Owner: Charles Blouin Phone # _____
 Address: 710 Warren Ave; Ptd. 4E 04103
LOCATION OF CONSTRUCTION 710 Warren Ave.
 Contractor: Downtown Energy Sub; 792-5595
 Address: 172 Main St; So Ptd. 4E Phone # 04105
 Est. Construction Cost: _____ Proposed Use: sheetmetal shop
 Past Use: _____
 # of Existing Res. Units _____ # of New Res. Units _____
 Building Dimensions L _____ W _____ Total Sq. Ft. _____
 # Stories: _____ # Bedrooms _____ Lot Size: _____
 Is Proposed Use: Seasonal _____ Condominium _____ Conversion _____
 Explain Conversion Install one 25/gal 1000-gal propane tank

Re: 710 Warren Ave

Your application to install one above ground 1000 gallon propane tank has been reviewed and a permit is herewith issued subject to the following requirements:

1000 gnl
propane

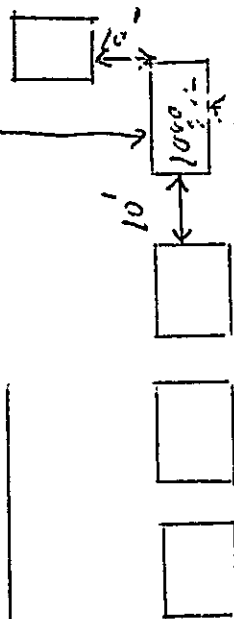
1. All above ground L/P storage tanks shall be located in accordance with NFPA #58 standings.
2. Any tank located near the path of vehicle movement shall be protected with appropriate permanent barricades.
3. All piping shall be protected from possible mechanical damage and vandalism.
4. The proposed tank location must be revised to meet the 10' setback from the property line as per Table 3-2.2.2 note (c) as required by Section 3-2.2.2.
